STAFF RECOMMENDATION
3657 Richland Avenue
Lot 1, Richland Hall Development
December 16, 2015

Application: New construction—infill and outbuilding; Setback determination
District: Richland-West End Neighborhood Conservation Zoning Overlay
Council District: 24
Map and Parcel Number: 10409028000
Applicant: Chad Gore, Mike Ford Builders
Project Lead: Melissa Baldock, melissa.baldock@nashville.gov

Description of Project: Application is to construct a new single-family infill and an outbuilding. Both the infill and the outbuilding are to be located three feet (3') from the interior property line. Since base zoning requires a five foot (5') side setback for both structures, the project requires a setback determination

ELEVATIONS

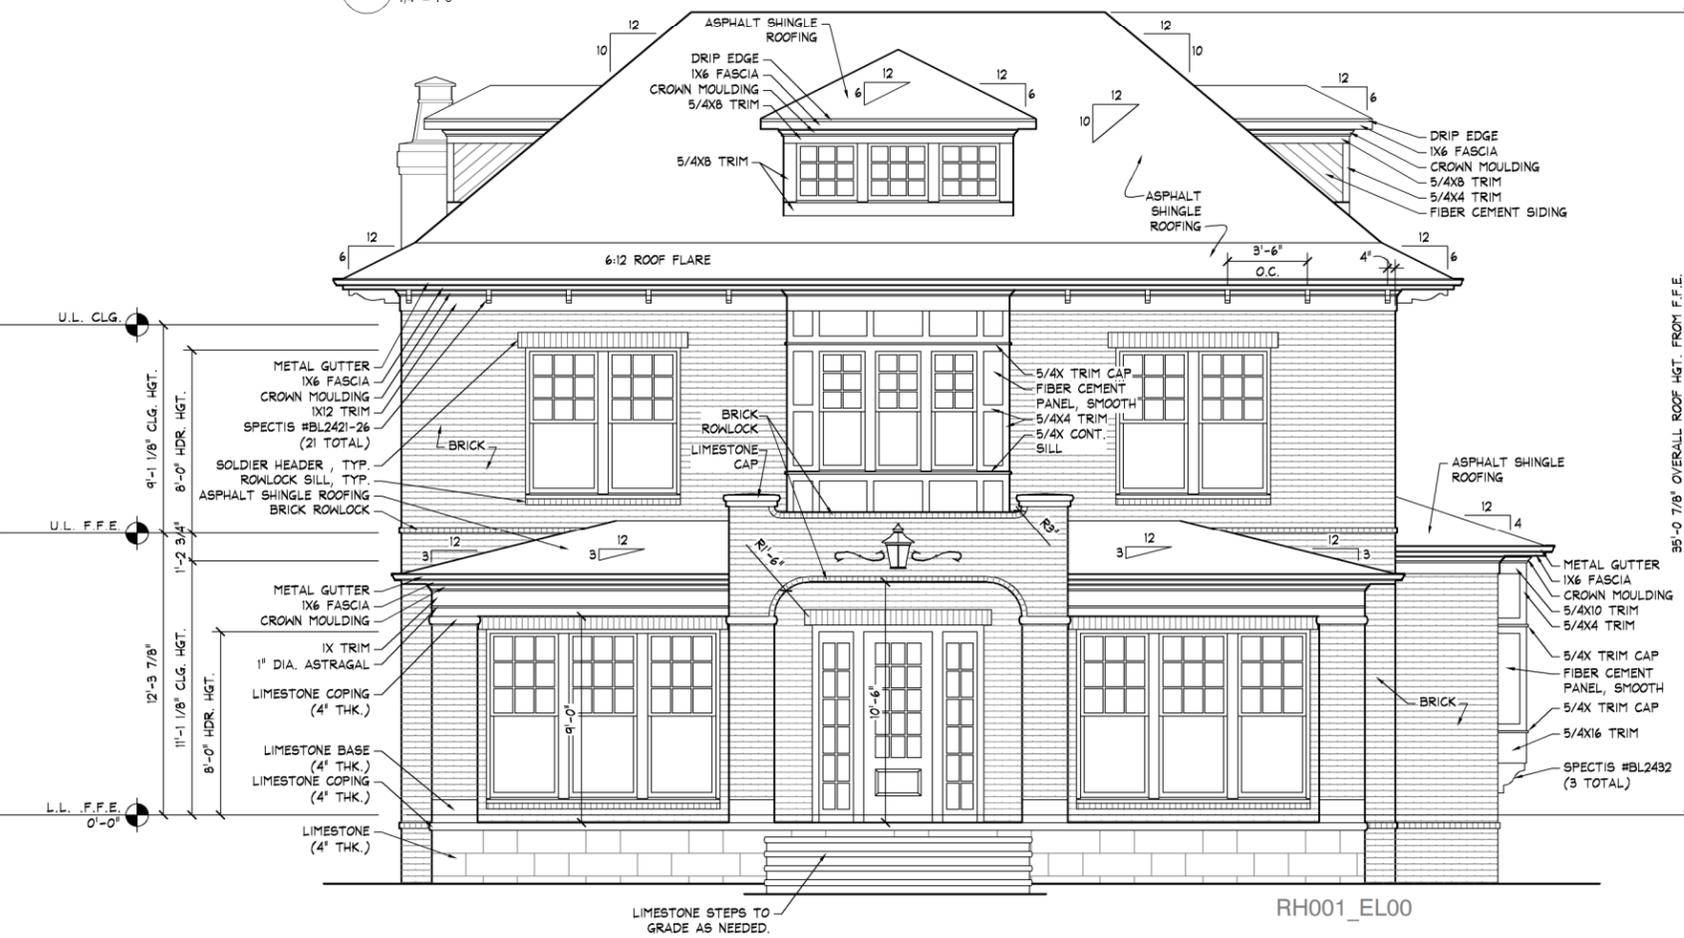
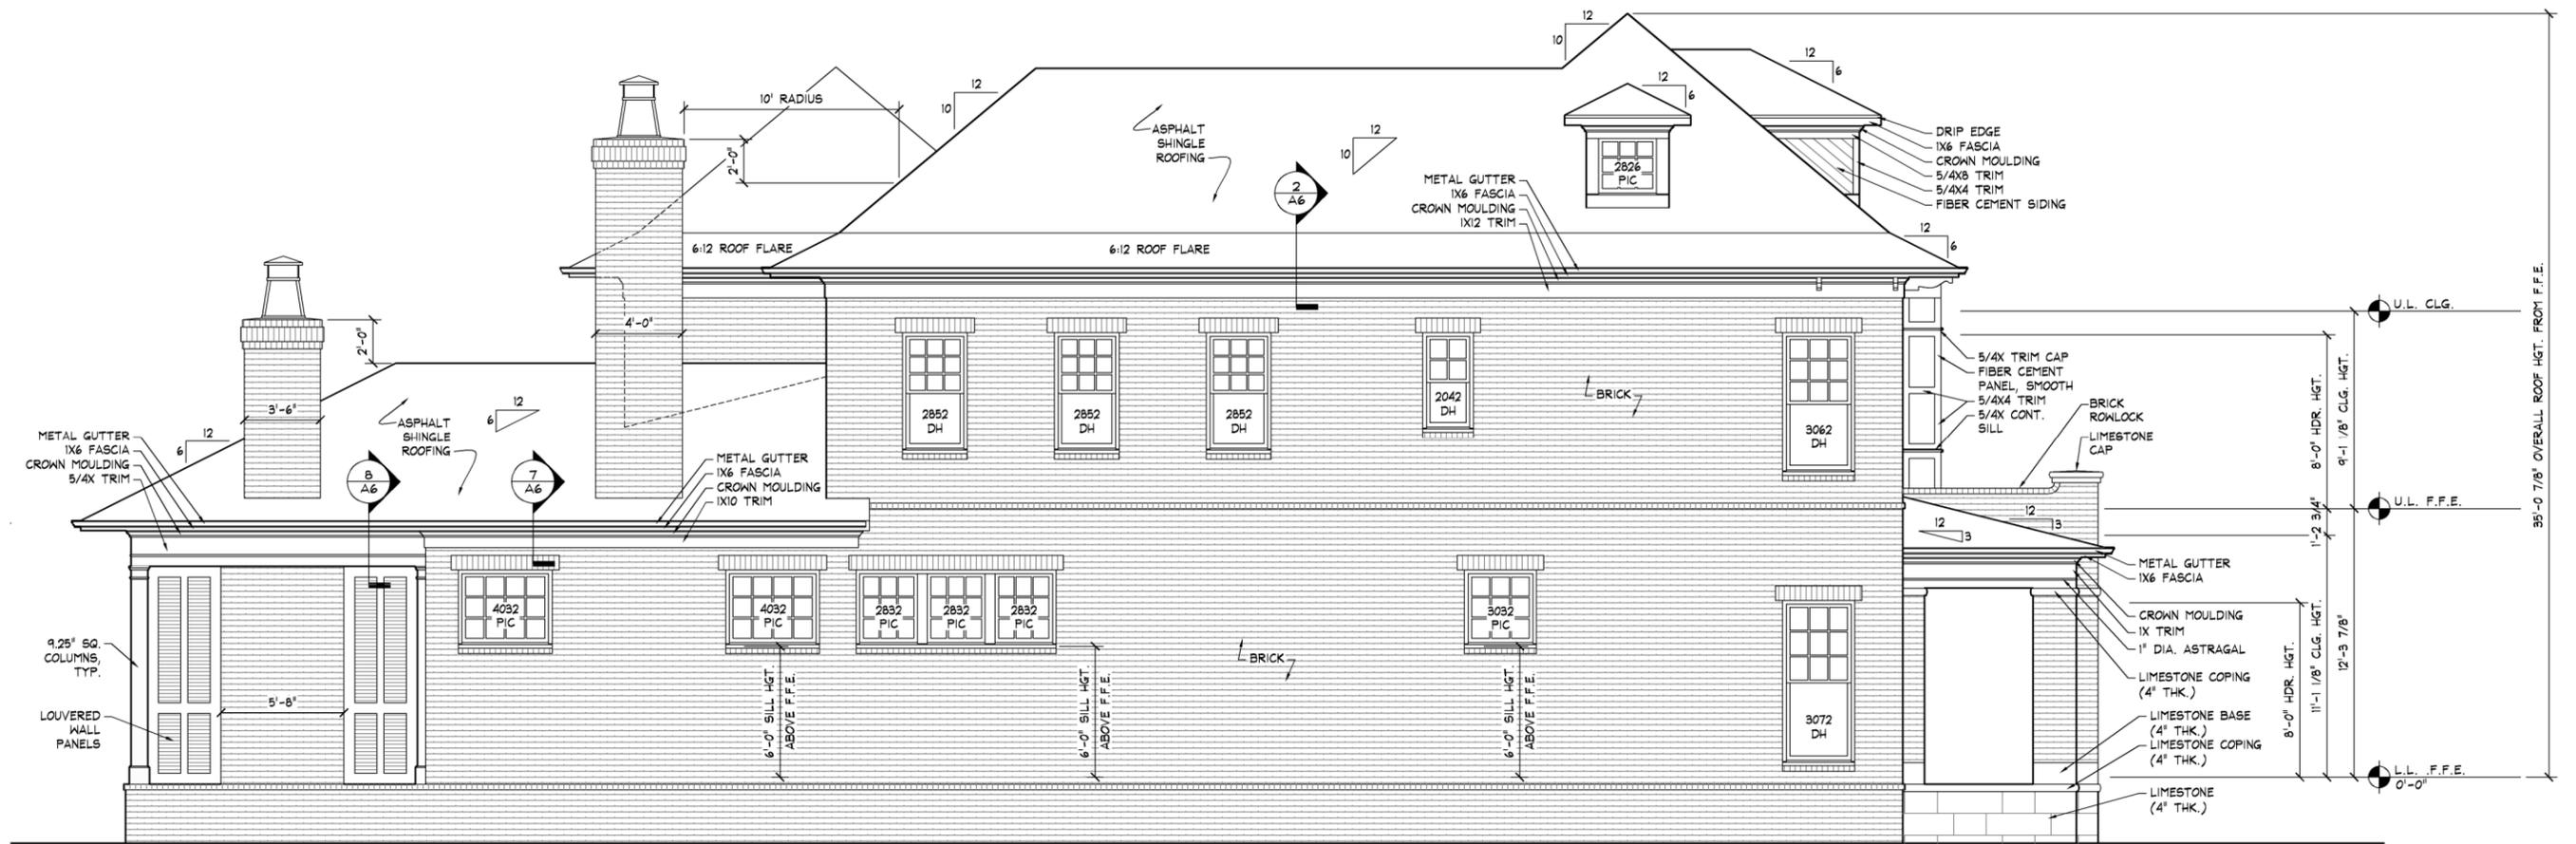
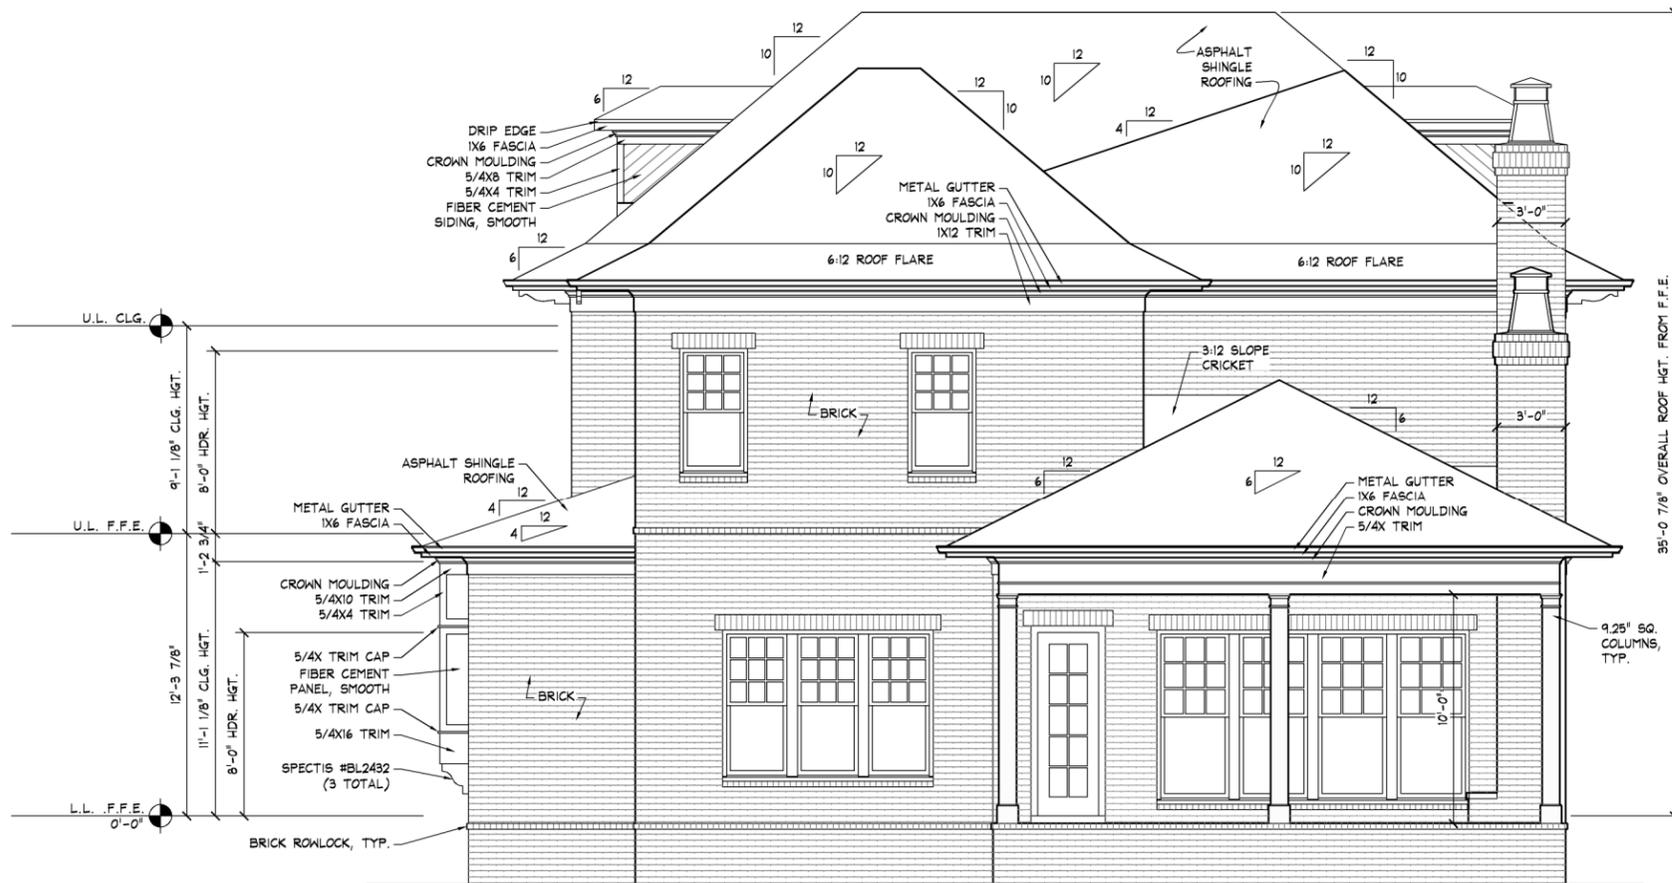
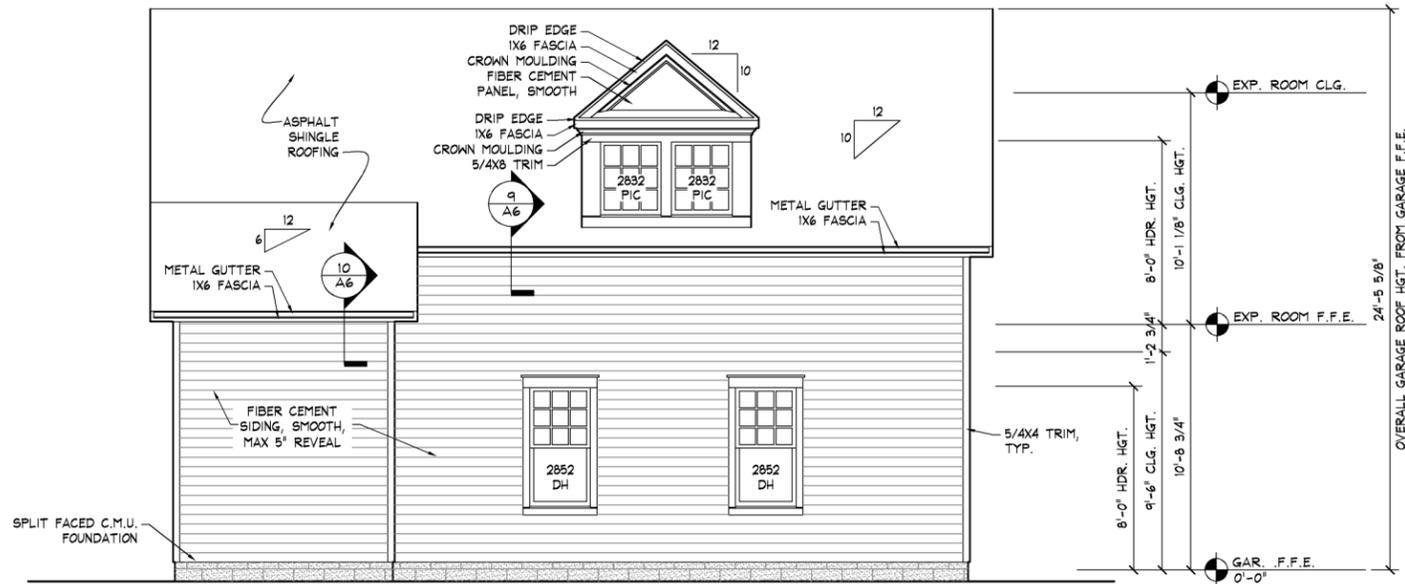
Height & Scale: The proposed infill will be two stories with an eave height of approximately twenty-six feet (26') from grade and a ridge height of approximately

thirty-eight feet (38') from grade. Staff finds that this meets the overall historic context, as there are several two-story houses across the street from the site, and these houses have heights ranging from thirty to forty-four feet (30' – 40'). The foundation height is drawn as approximately two feet, six inches (2'6"). The lot is fairly flat and staff recommends that the foundation be no taller than two feet (2') at its highest point. The porch roof will have an eave height of approximately thirteen feet (13') from grade, which is appropriate.

Materials: The primary cladding material will be brick, and staff recommends approval of a brick sample prior to purchase and installation. The primary foundation is also to be brick, with a header brick course separating the foundation from the wall above. Historically, there was a change in material from the foundation to the wall above, and staff therefore recommends that the foundation be another masonry material than brick, like stone or stucco. Alternatively, if the foundation is to be brick, then the color of the

The porch foundation will be limestone, and staff recommends approval of a stone sample prior to purchase and installation. Limestone will also be used as an accent material on the porch. Smooth fiber cement panels will be used on the front and side bays. Smooth-face fiber cement lap siding with a five inch (5") reveal will be used on the dormers and on an area on the Craighead side façade. On the dormers, the siding is proposed to be installed at an angle, matching the slope of the roof. Historically, siding on dormers was installed horizontally; however, since this is such a minor detail, staff found it to be appropriate for minor construction. The trim will be wood or cement fiberboard. The roof will be asphalt shingle, and staff recommends approval of the shingle color and texture. The materials of the windows and doors were not specified, and staff recommends approval of all window and door specifications prior to purchase and installation. Likewise, staff recommends approval of the closed shutter materials and design.

Roof form: The primary roof form is a hipped roof with a 10/12 pitch. There are three hipped dormers with 6/12 pitches; one is on the front façade, and there is one each on the side façades. These dormers are set off the ridge of the roof and are set back two feet (2') from the wall below. The central part of the porch roof is flat, and it is flanked by a hipped porch roof with a slope of 3/12. On the Craighead elevation, there are two primary hipped roof forms that are connected via another hipped roof with a slope of 4/12. The Craighead façade also has a one-story bay with a 4/12 roof form. Staff finds that the proposed roof forms are typical for historic two-story houses in the overlay, and finds that the roof forms meet Section II.B.1.e. of the design guidelines.

Proportion and Rhythm of Openings: The primary windows on the infill are twice as tall as they are wide, thereby meeting the historic proportions of openings. The primary windows on the ground floor are taller than those on the upper stories. On the Craighead façade, the applicant is proposing several openings that will be permanently closed up with shutters. The Commission has approved permanently shuttered window openings like these in the past as a way to break-up a long wall without adding windows that conflict with the use of interior space. There are no large expanses of wall space without a window or door opening on the Craighead facade. On the left elevation, there is an expanse of nineteen feet (19') without a window or a door opening. Staff finds this

expanse to be appropriate because it is on the interior of the lot, and is located over twenty feet (20') behind the front wall of the house, minimizing its visibility. Staff finds that the infill's proportion and rhythm of openings meet Section II.B.1.g. of the design guidelines.

1. The foundation be no taller than two feet (2');
2. The finished floor height be consistent with the finished floor heights of the adjacent historic houses, to be verified by MHZC staff in the field;
3. The foundation material be stone or stucco, or if the foundation is to be brick, it be a different color than the brick on the walls above in order to visually differentiate between the foundation and the wall;
4. Staff approve all windows and doors, roof shingle color, and brick and stone samples prior to purchase and installation of these materials;
5. The Welch Library piers and lights be relocated to flank the new alley, unless the existing Welch Library entrance is to remain;
6. Staff approve the materials, size, design, and location of the alley sign; and
7. The HVAC shall be located behind the house or on the interior side facade, beyond the mid-point of the house.

GARAGE ELEVATIONS

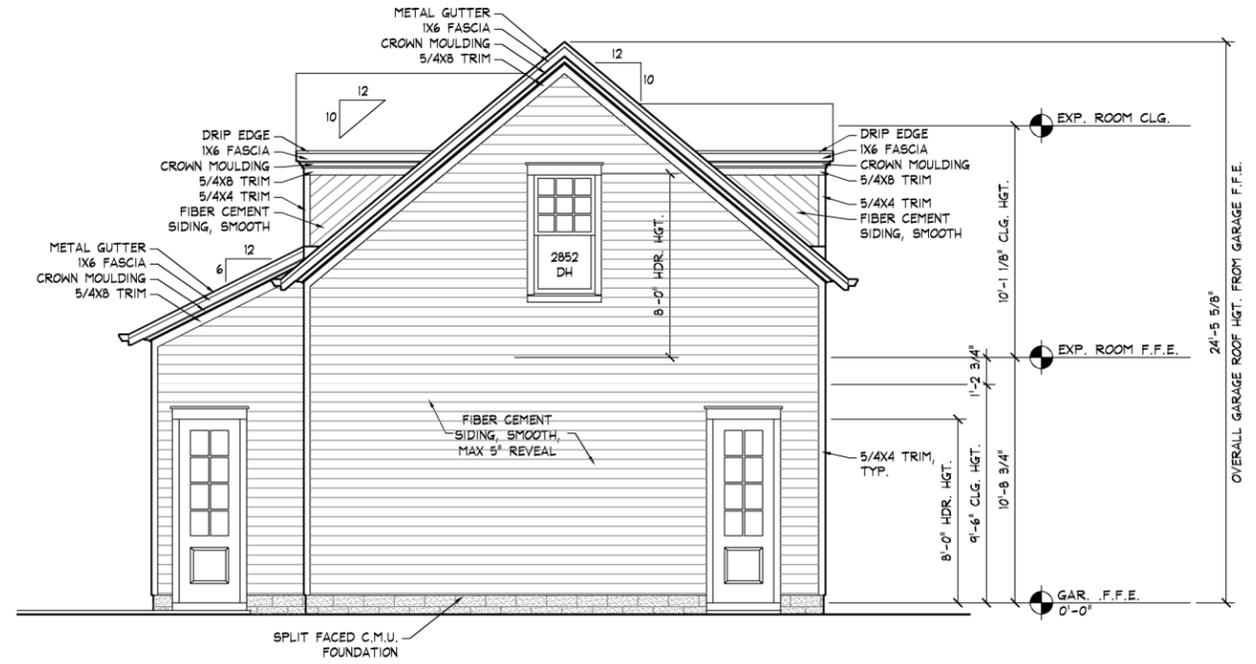
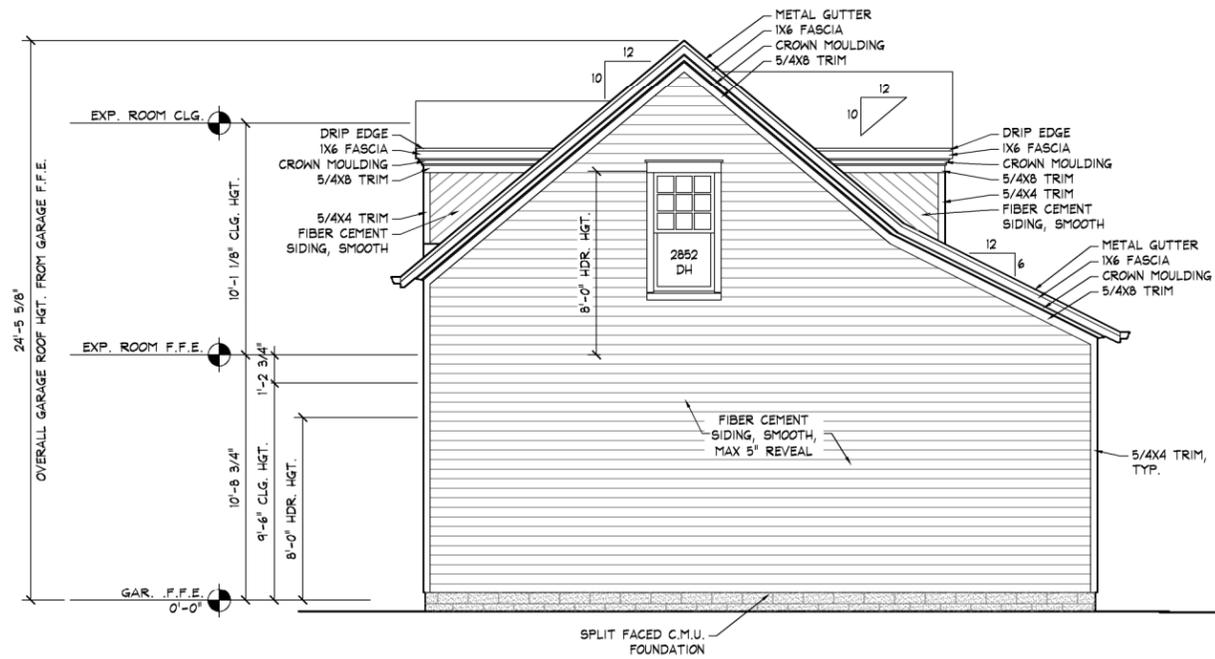
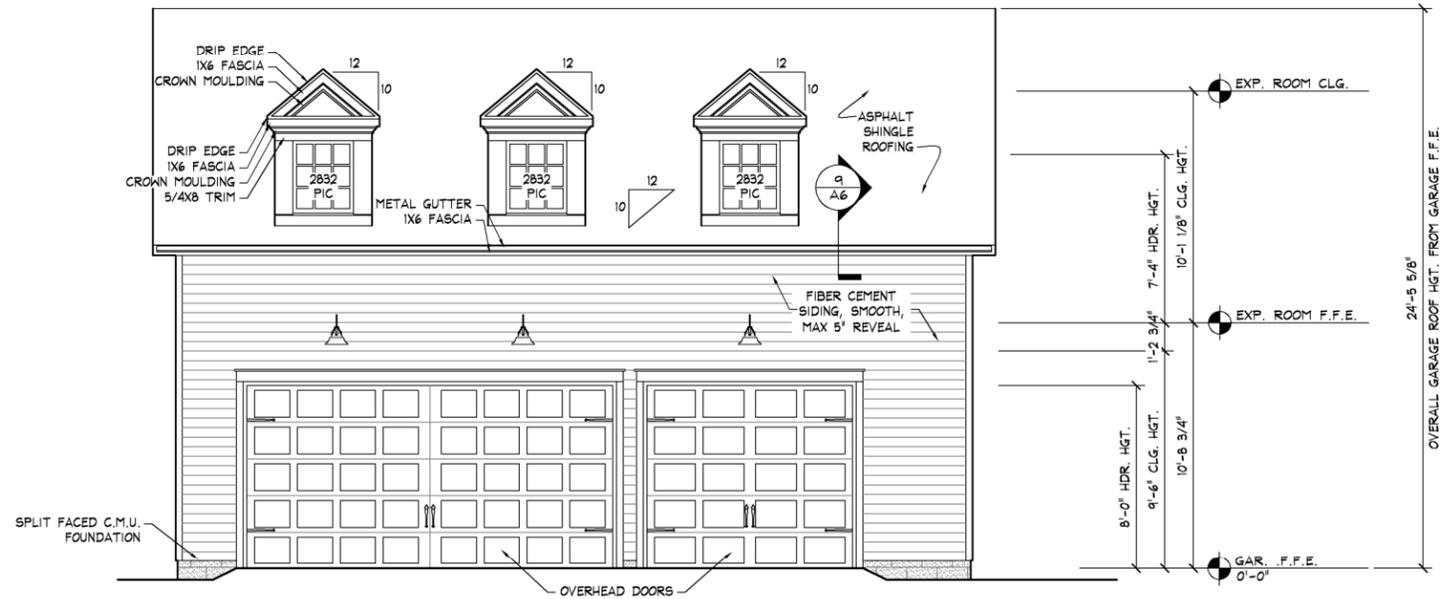
Outbuildings: See the attached Outbuilding Worksheet for a full analysis of how the proposed outbuilding meets the design guidelines. The outbuilding is not approved as a Detached Accessory Dwelling Unit, as the neighborhood is zoned for single family use. The outbuilding's footprint is approximately eight hundred and eighty-two square feet (882 sq. ft.), which is appropriate since the lot is over thirteen thousand square feet (13,000 sq. ft.). The outbuilding will be accessed via a new private alley at the rear of the property. The garage doors will face the alley.

Base zoning requires that outbuildings larger than seven hundred square feet (700 sq. ft.) be located twenty feet (20') from the rear property line, twenty feet (20') from a side street property line, and five feet (5') from the interior side property line. The

outbuilding will be approximately thirty feet (30') from the rear property line, although it will appear to be much closer because it is five feet (5') from the new alley created on the rear of the property. The outbuilding will meet the Craighead Avenue setback, but will require a side setback determination for the interior side setback. It will be just three feet (3') from the side property line rather than the required five feet (5'). Staff finds the proposed three foot (3') side setback to be appropriate because it will line up with the setback of the proposed infill. In addition, historically, outbuildings were located close to or on the side property lines. There will be approximately ten feet (10') between the infill and the outbuilding.

The known materials for the outbuilding have all been approved by the Commission in the past and include smooth-face cement fiberboard lap siding with a five inch (5") reveal. The foundation will be split face concrete block, and the roof will be asphalt shingles. Staff recommends approval of all windows and doors prior to purchase and installation.
